Proposal #06: 1060-27-71, WISC 2025596
I-94 East West, West Leg
70th Street to Zablocki Drive
IH 094
Milwaukee County

This is Addendum No. 03, which provides for the following:

ADDENDUM NO. 03

1060-27-71

Addendum No. 03
ID 1060-27-71
Revised Sheet 622
September 4, 2025

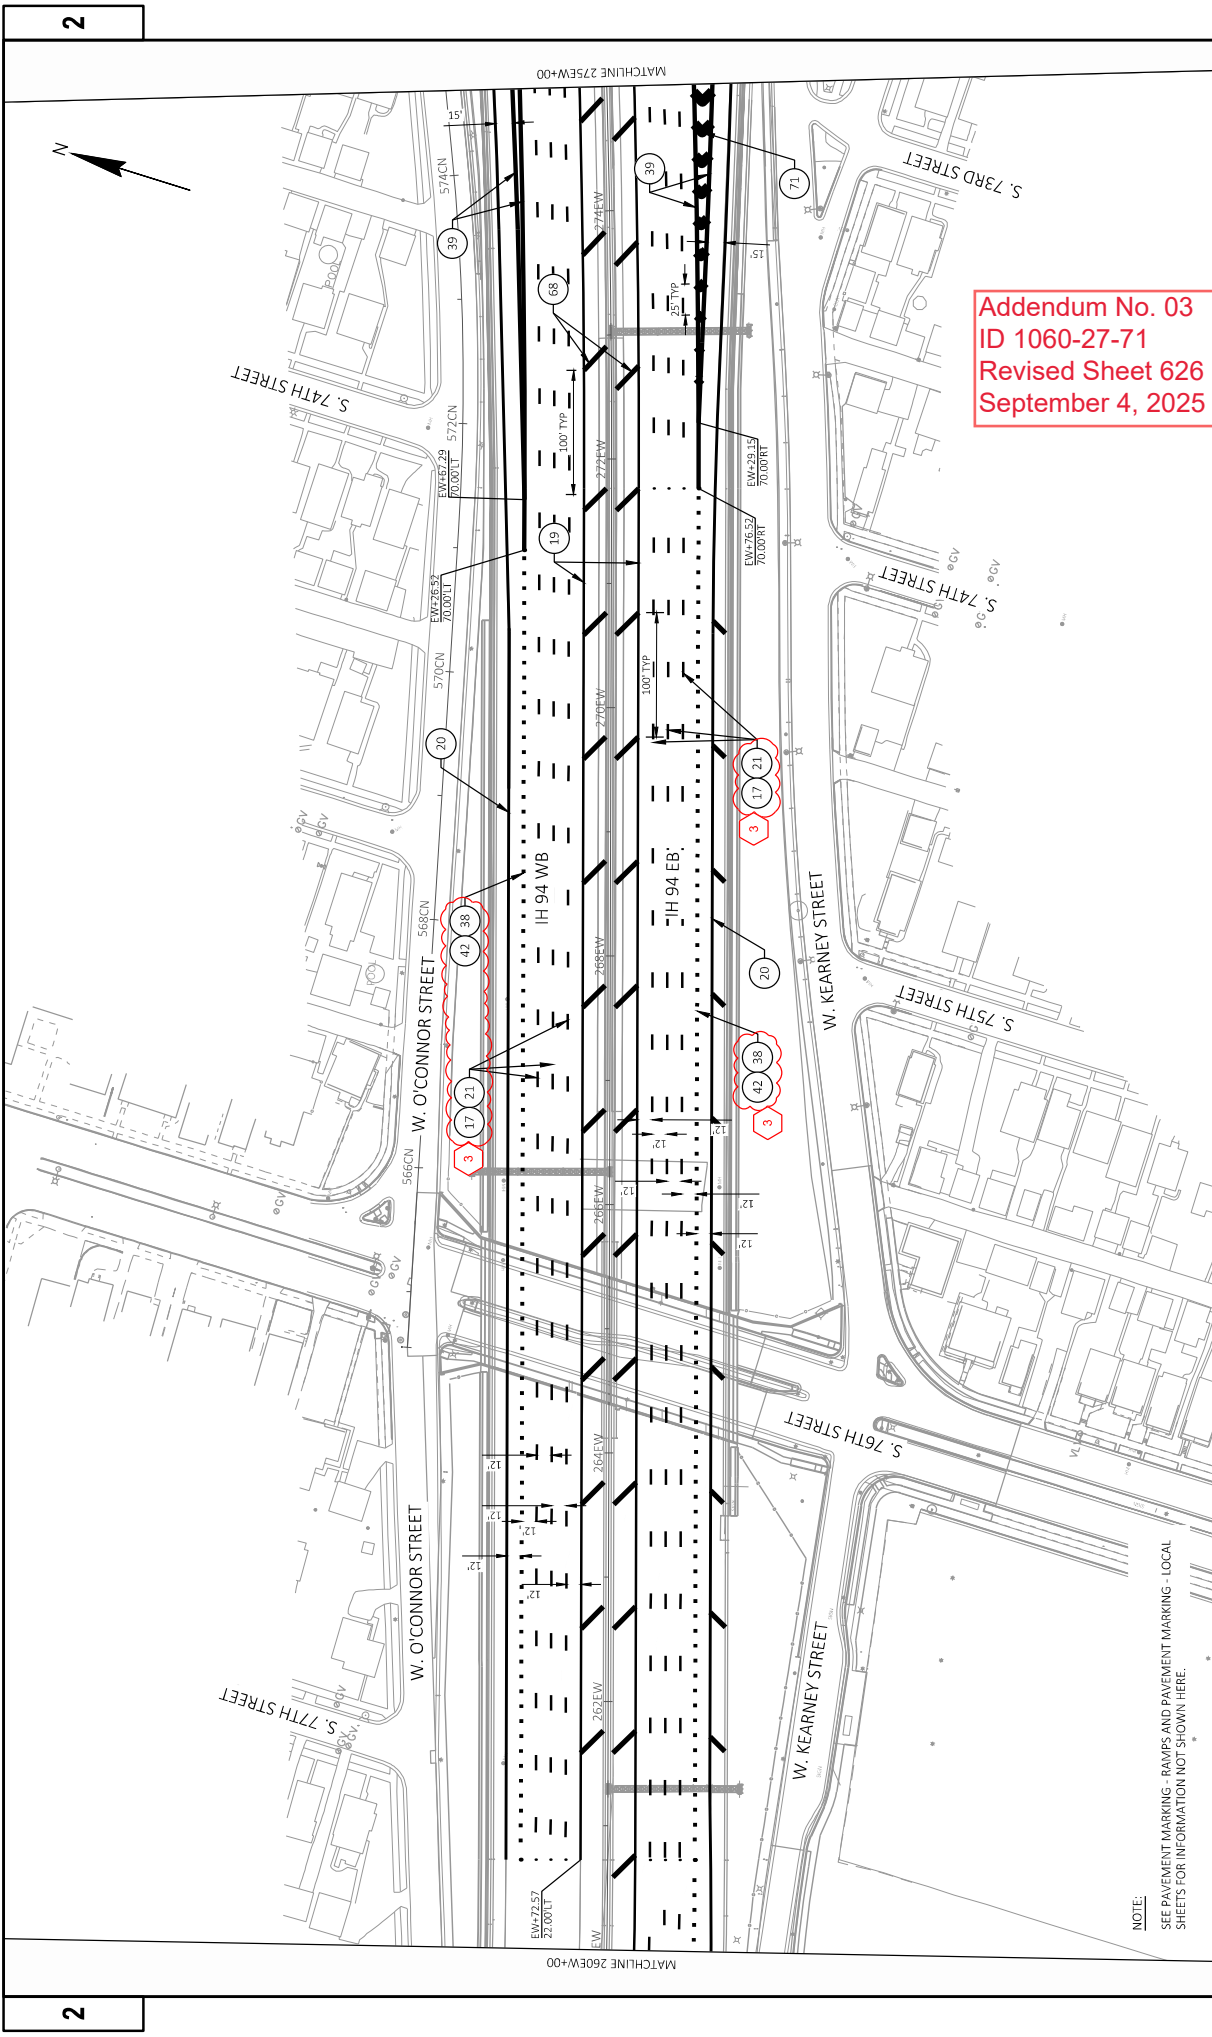
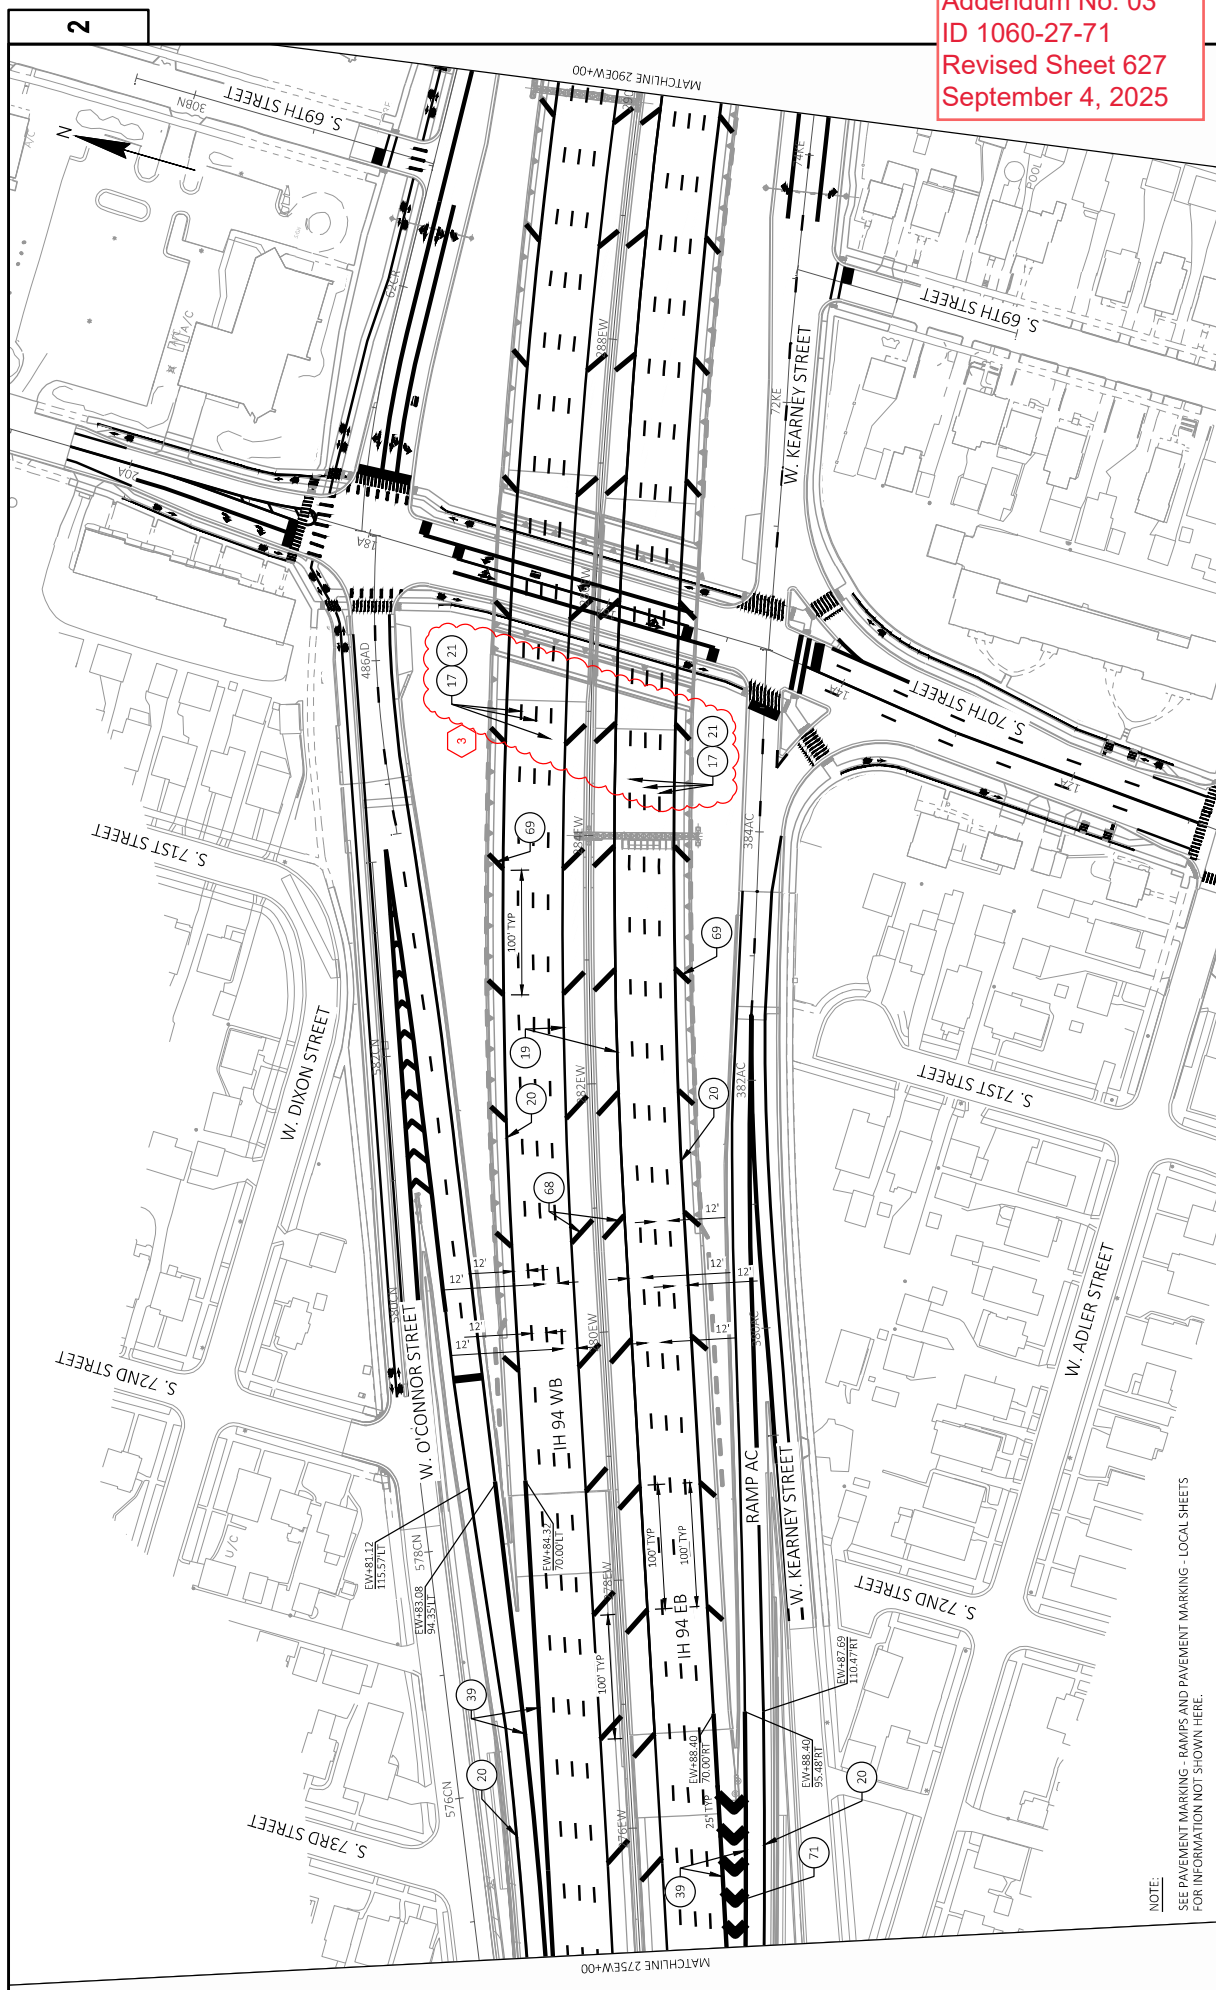
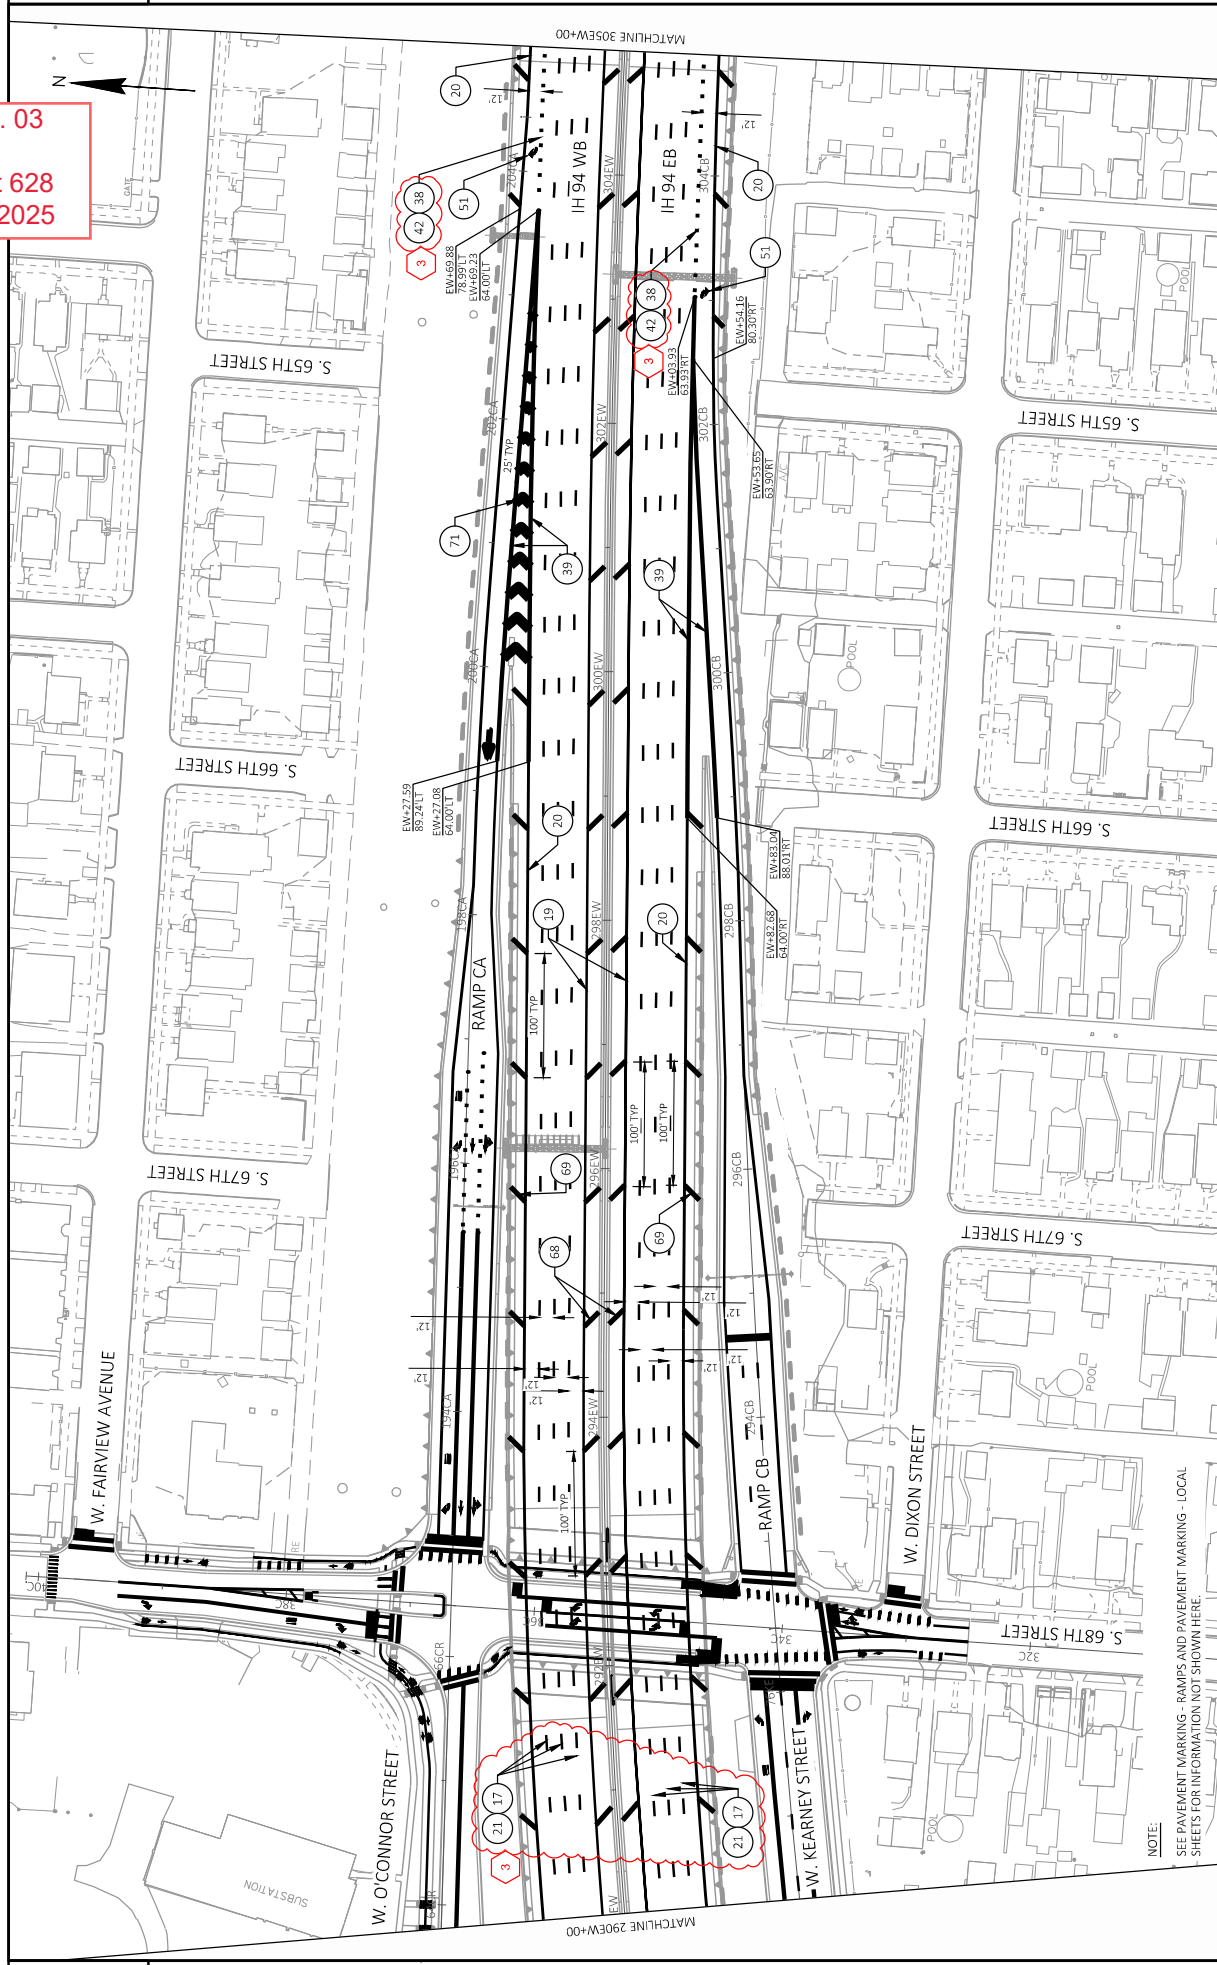
Revised Plan Sheets	
Plan Sheet	Plan Sheet Title (brief description of changes to sheet)
622-630	Pavement Marking: Changed all Permanent Tape markings to Wet Ref Epoxy
960-961	Miscellaneous Quantities: Changed all Permanent Tape markings to Wet Ref Epoxy
1166	Miscellaneous Quantities: Added table for open cut storm crossing pavement replacement
2110	R-40-741 General Plan & Elevation: Revised Note
2114	R-40-741 Anchor Slab Details: Revised Dimension
2115	R-40-741 Parapet Transition Detail: Revised Dimension
2120	R-40-742 General Plan & Elevation: Revised Note
2123	R-40-742 Anchor Slab Details: Revised Dimension
2143	R-40-762 General Plan & Elevation: Revised Note
2193	Monotube & 2-Chord General Data & Design Date: Quantity Updates for S-40-3111 & S-40-3114
